Docket: NRC-2015-0051

Department of Energy; Yucca Mountain, Nye County, Nevada; Supplemental Environmental Impact Statement

Document: NRC-2015-0051-DRAFT-0050

Comments to Groundwater Comments Supplemental Environmental Impact Statement Aug. 21, 2015.

Furthermore, the NRC adopted a 2009 COE publication entitled "Analysis Post closer Groundwater Impact (2009). Upon reviewing the NRC document of 2009 Vol 3 which contain a major scientific errors as shone in **Figure 1. Illustrates Daily intakes of**

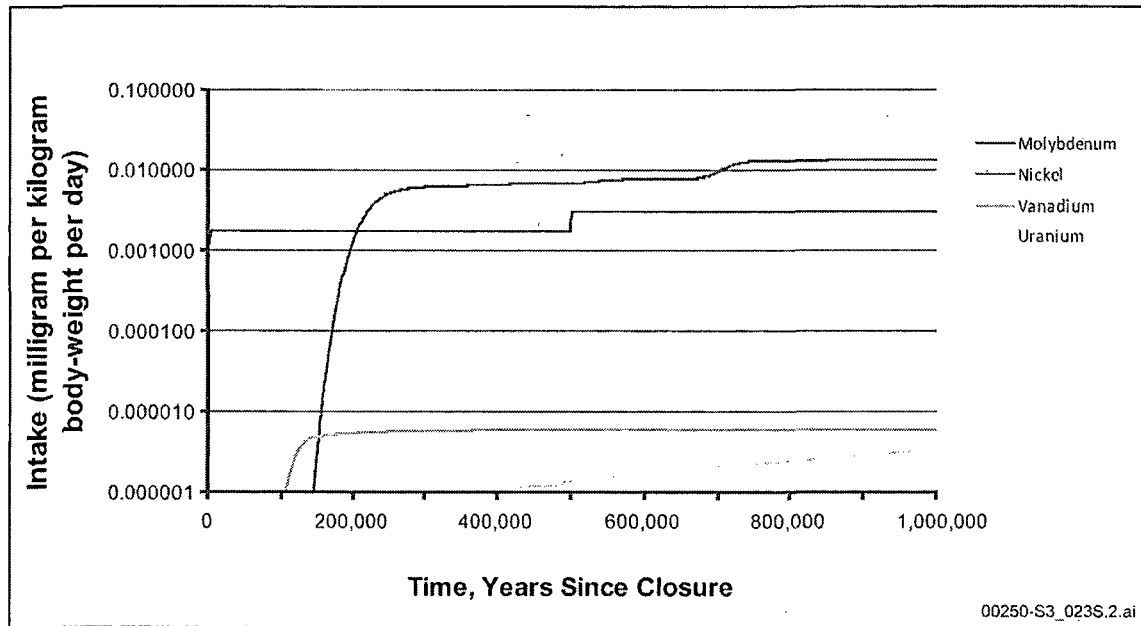
- **Why Cr, a potent carcinogen, and V excluded were excluded from daily intake?**
- Since, about 43,300 tons of chromium will be deposited at YMP Site (EIS 2002) in addition to the 70,000 tons of radionuclides what credible scientific explanation the DOE and the NRC can provide a scientific Justification since no data were provided for the near zone.

- Next, it is unclear if the sorption of zeolite followed the proper scientific order where light elements replaced heavy elements. This is **incorrect Mo>V>Ni>U** as showed in Figure 1.
